Botanic Ridge PSP

Submission for the GAA draft Precinct Structure Plans open for public comment

Using the Planning Checklist for Cycling as an evaluation tool, Bicycle Network Victoria offers the following suggestions for the draft Botanic Ridge Precinct Structure Plan (see attached annotated plan and table):

Figure 1: Annotated plan with bicycle comments.

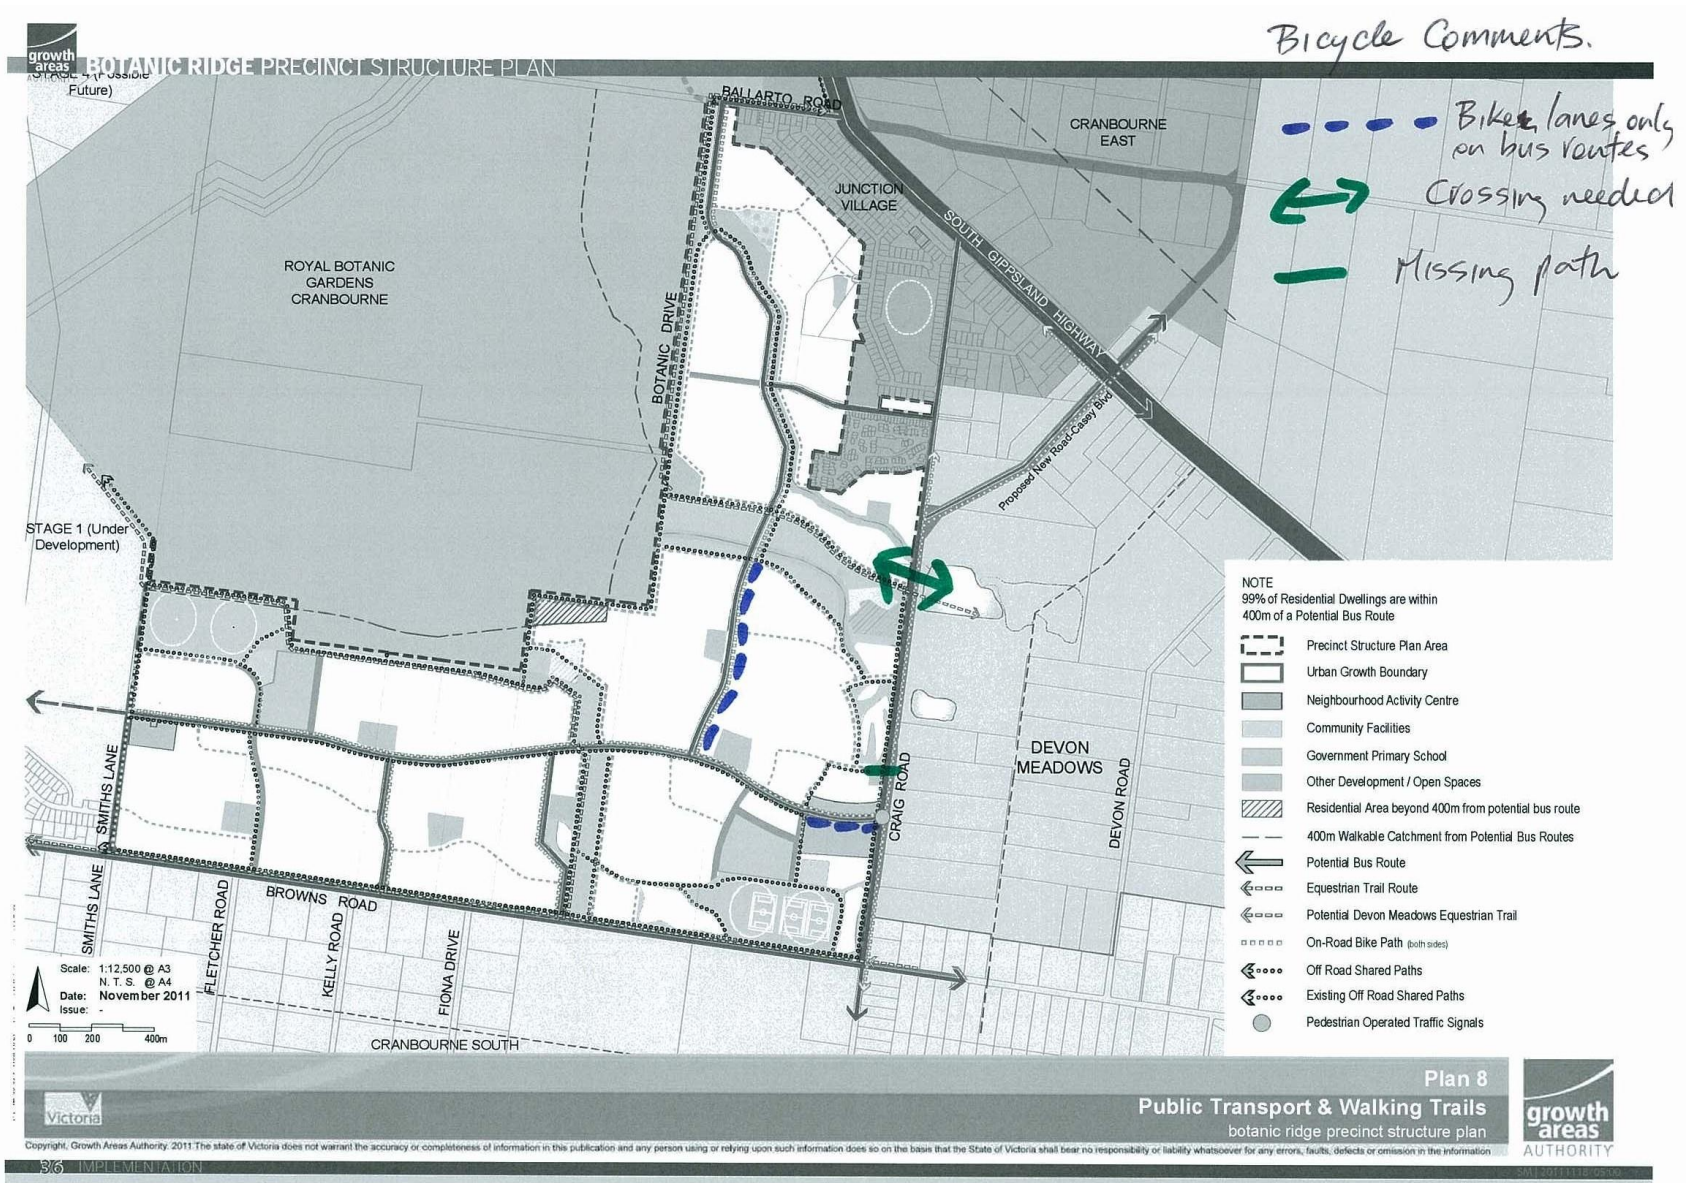
Connections to destinations - The south eastern Local Town Centre (LTC) is well connected via off-road paths and on-road lanes though an off-road bike path on the central connector street should be provided. The smaller south western local activity centre is also well connected via a shared path on the east-west connector street.

Access to Schools, Parks Community Centres – All the schools, community centres and active open spaces proposed have off-road path connections to the wider off road path network including paths along fire buffers and bio-links. Off-road paths on connector streets help enhance access to schools and community centres. There is a short section of path missing at the heritage site in the SE section of the plan area. This would prevent access to and from the Craig Road shared path.

Crossing of barriers – Craig Road to the east is a potential significant barrier for permeability to the east. It lacks a crossing for the Metro Trail Network path between the SE LTC and the intersection of Casey Blvd. An underpass or signalised at grade crossing should be provided at the point where the MTN path intersects with Craig Rd to allow access to and from the east – a signalised crossing or underpass is preferred rather than an overpass.

Connector streets with buses and bikes - Some of the connector streets have marked on-road bike lanes on potential bus routes. This may lead to conflict between buses and bikes as buses must cross and recross the bike lane to load and unload passengers. Off-road bike paths are more appropriate on these routes as bicycles can run behind stops and high frequency bus services will not be hindered in their operation. Off –road bike paths also mean a narrower paved road width which is easier for pedestrians and potential bus passengers to cross. Shared off road paths are proposed along most connector streets expect a section of the north south connector street and a short section though the SE LTC (see annotated plan attached).

Bike lanes on high speed roads – Craig Rd, Browns Rd and Casey Blvd are higher speed arterial roads which propose on-road bike lanes alongside motor vehicles travelling above 70-80km/h. Austroads Guides to Road Design (2009, 2011) recommend separated bike paths for these traffic regimes and these are much more likely to be used by less confident and novice bike riders such as children and family groups who do the majority of riding in the community via short trips to school, shops and friend and for recreation. Separated, bike only paths are more appropriate for these roads but care needs to be taken to design intersections and cross overs (driveways etc.) to provide clear and unhindered passage for bike riders. A bike path that stops and gives way at minor intersections does not properly provide or encourage bike riding.

Separated bike paths from pedestrians – where high volumes of bikes riders and pedestrians are expected, especially at peak times such as before and after school, there is the potential for conflict on shared paths. This can be seen on some of the most popular existing shared paths in Melbourne such as the Main Yarra Trail and the Inner Circle Trail where high volumes of bike riders and walkers mean both are disadvantaged. This can discourage walking and cycling; especially by the more vulnerable who may be fearful of venturing onto a busy shared space. Widening of the path only works up to a certain point and then it makes more sense to provide separated bike and pedestrian paths. Experience and modelling has shown that where peak bicycle volumes exceed 200 bikes per hour with more than 100 pedestrians per hour then separate bike and pedestrian paths are appropriate. The links from the SE active open space past the school and community centre to the Local Town Centre would be candidates for separated bike paths rather than a shared path.
